SERVICE BULLETIN

No: SB_SD4-02-2023

MODEL AFFECTED:	Viper SD-4 RTC and Viper SD-4 Night VFR aircrafts Aircrafts in conformity with EASA.A.606, Issue 3, 01.April 2019
APPLICABILITY:	Criterion A) <u>Aircrafts</u> Viper SD-4 RTC aircrafts S/N: 31613 or later. <i>(if older, contact TOMARK, s.r.o before starting work)</i> Viper SD-4 Night VFR aircrafts S/N: 30181 or later. <i>(if older, contact TOMARK, s.r.o before starting work)</i> Criterion B) <u>Two DYNON SkyView classic SV-D1000 displays installed</u> Each Viper SD-4 RTC or Viper SD-4 Night VFR aircraft equipped by two DYNON SkyView classic SV-D1000 displays during aircraft manufacturing, repair, maintenance or general overhaul or any other exchange action.
SUBJECT:	Installation of two DYNON SkyView HDX displays (SV-HDX1100) ATA System: 31-10 INDICATING/RECORDING SYSTEMS - Instrument & Control Panels. 34-20 NAVIGATION - Attitude & Direction.
COMPLIANCE:	Implement this Service Bulletin when replacement of the original DYNON SkyView classic SV-D1000 displays by DYNON SkyView HDX SV-HDX1100 displays was identified as practical.

COMPLIANCE CATEGORY:	CAT - 4 - Application is optional
DESCRIPTION:	TOMARK, s.r.o. as holder of EASA.A.60

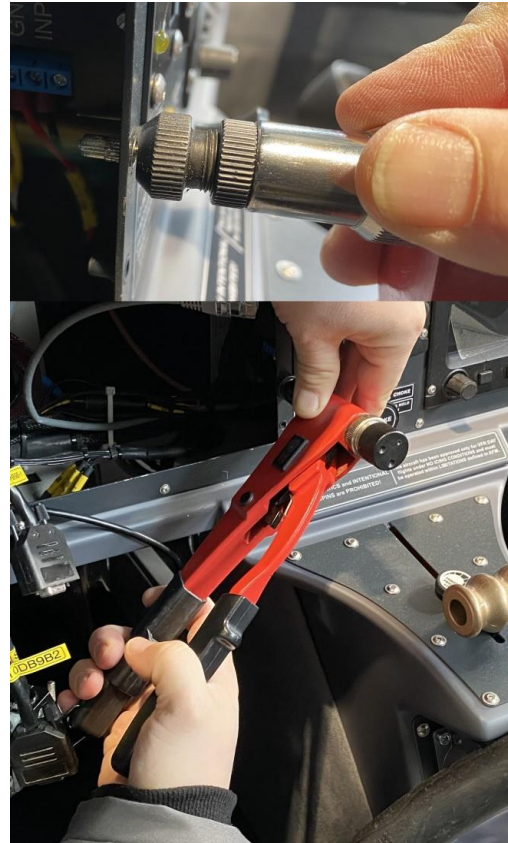
1. After demounting the Dynon SkyView classic SV-D1000 display, take the Dynon SkyView HDX SV-HDX1100 display and insert it into the SkyView mounting hole. Attach it with two M3x14 DIN 7985 A2 screws in the top part of the display.

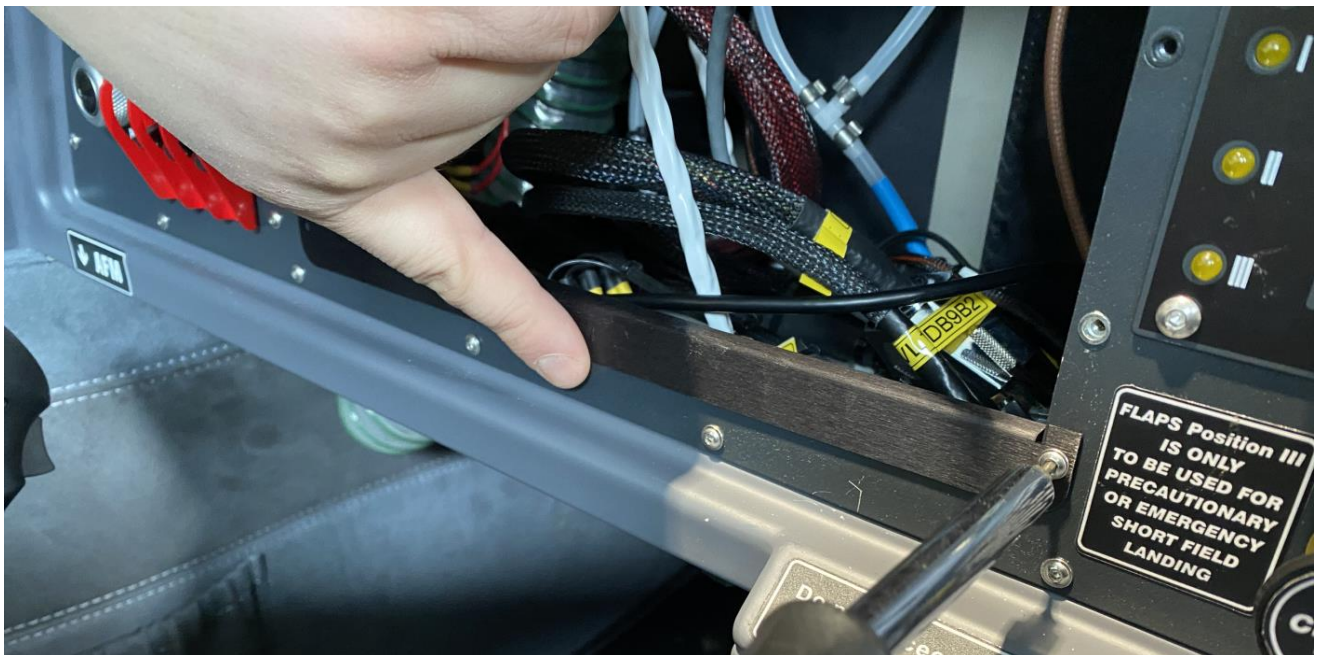
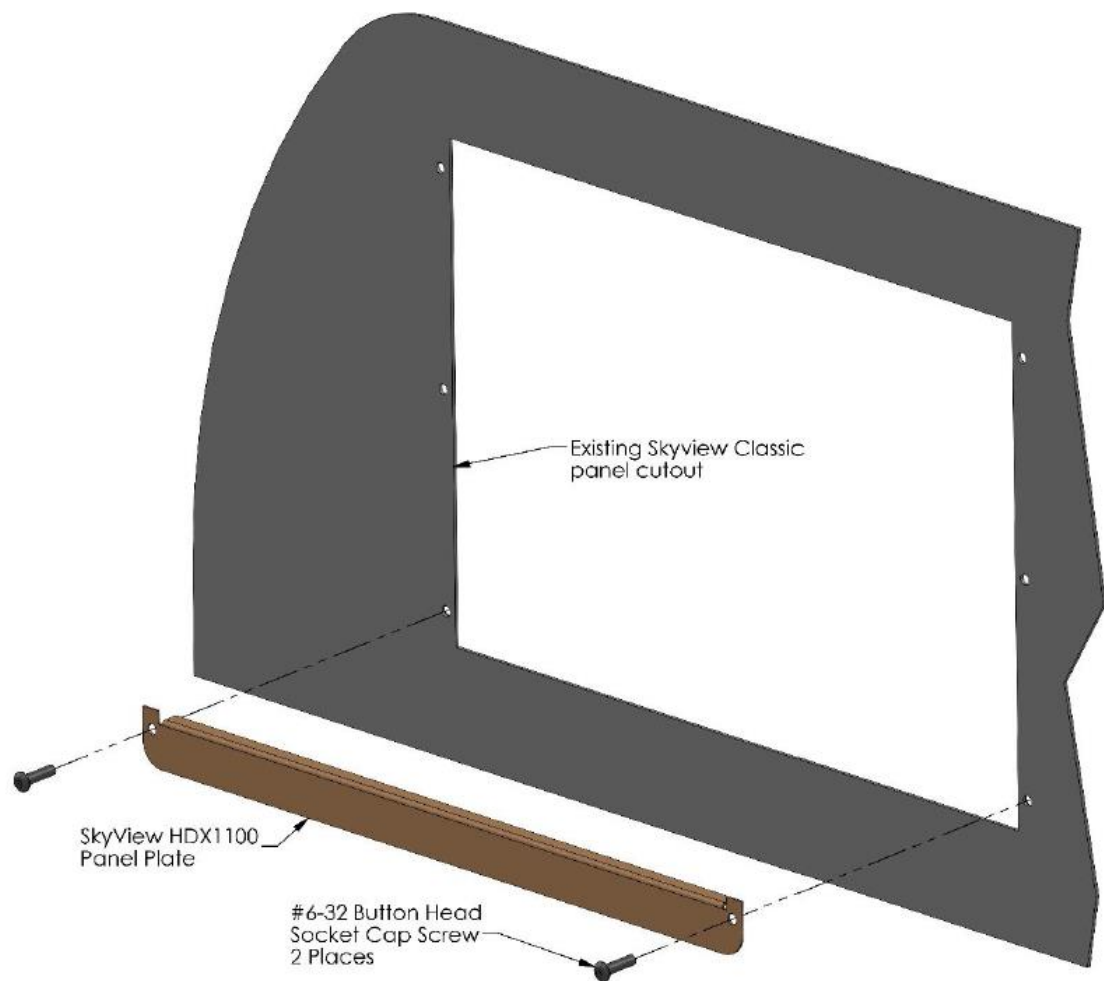
5. After drilling the holes, the mounting of the rivet nuts follows. Special pressing pliers are then used to carefully press the nuts onto the dashboard. Use the M3x10 riveting nut series 39006 and respective extender for riveting pliers. When pressing, take care to exert sufficient force on the pliers to press the nut firmly enough, but at the same time not to destroy it by stripping the threads.

6. After pressing the nuts, mount the "filler" Panel Plate (P/N 102897-000) /1/ by attaching it with the two socket screws (use the screws M3x12 AN9084 A2 with the original display installation) by a size 2 hex screwdriver.

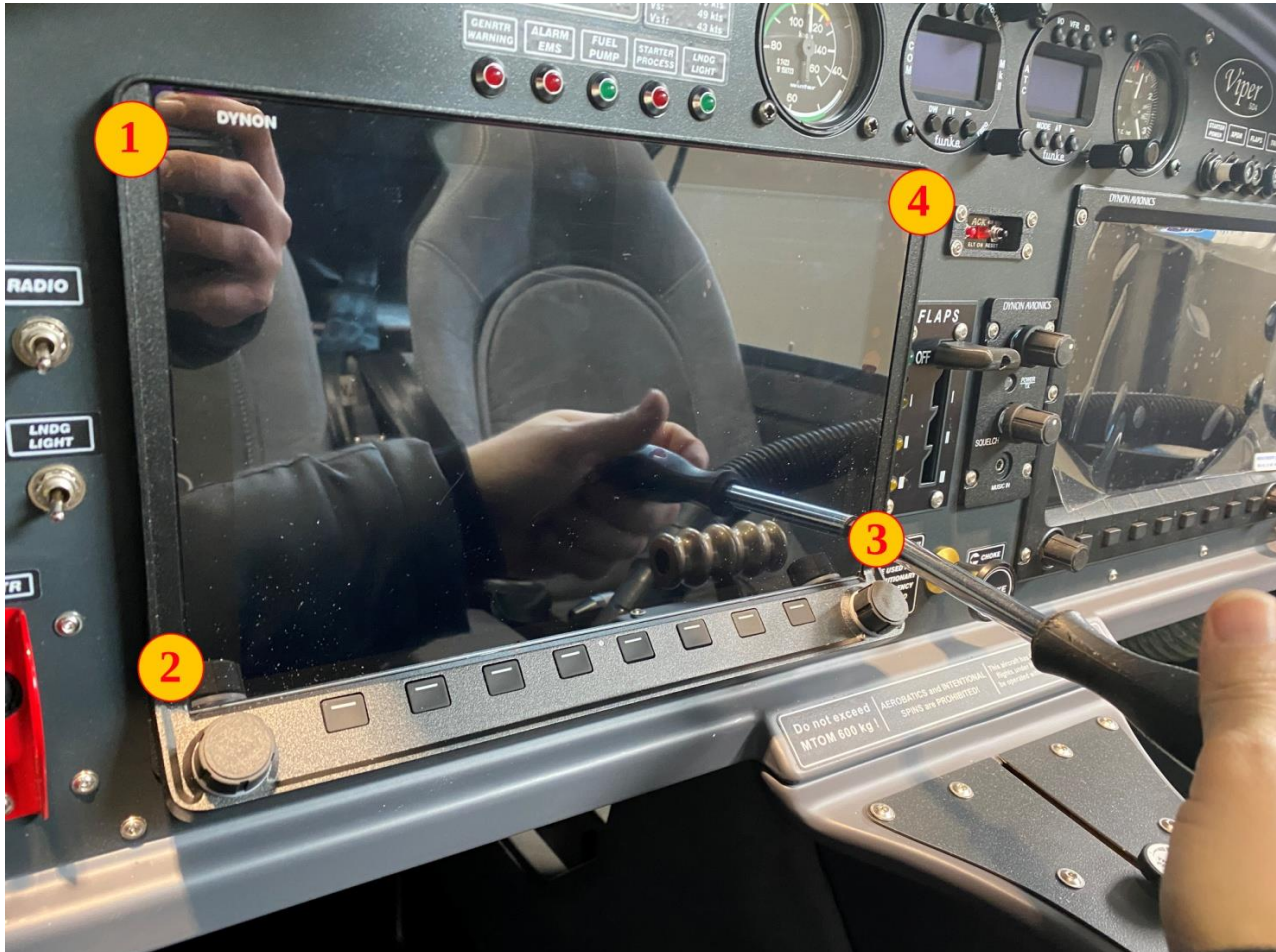
7. After the Panel Plate mounted, connect and mount the SkyView HDX 1100 display itself. When plugging in the connectors, proceed as for unplugging, but in reverse order (section B) 5).

8. Mount the connected SkyView HDX 1100 display in the modified mounting hole on the instrument panel. Use four M3x14 DIN 7985 A2 screws to secure the display.
